**Economic and Social Council**Distr.: General
2 July 2021

World Forum for Harmonization of Vehicle Regulations**Working Party on Noise and Tyres****Seventy-fourth session**

UN Regulation No. 63 (Noise emissions of mopeds)**Proposal for amendments to the 02 series of amendments to
UN Regulation No. 63****Submitted by the experts from the International Motorcycle
Manufacturers Association***

“Figure 1
Test track layout with dimensions in meters

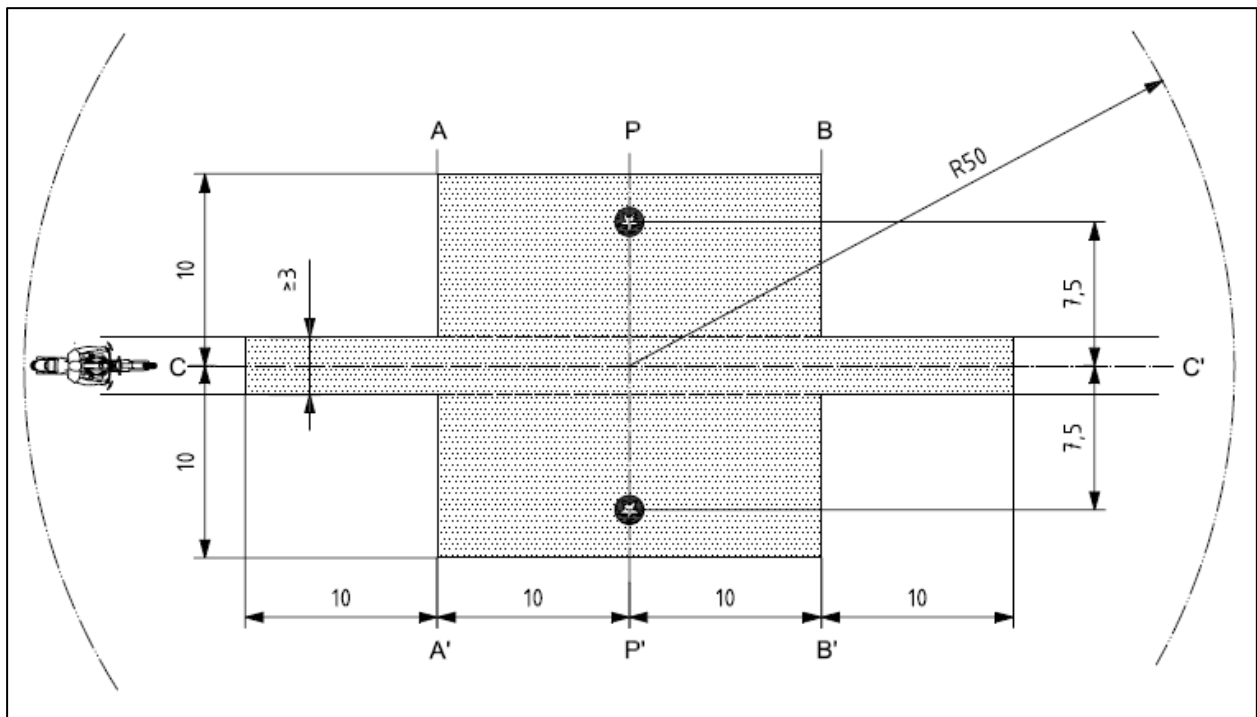
Figure 1, amend to read:

2. IMMA would like to replace the current Figure 1 of Annex 5 with the one above in a higher resolution. Such figure derives from an older version of ISO 10844; it was then

modified to include a picture of a motorcycle that was not in 10844. ISO has confirmed permission to use such a figure.
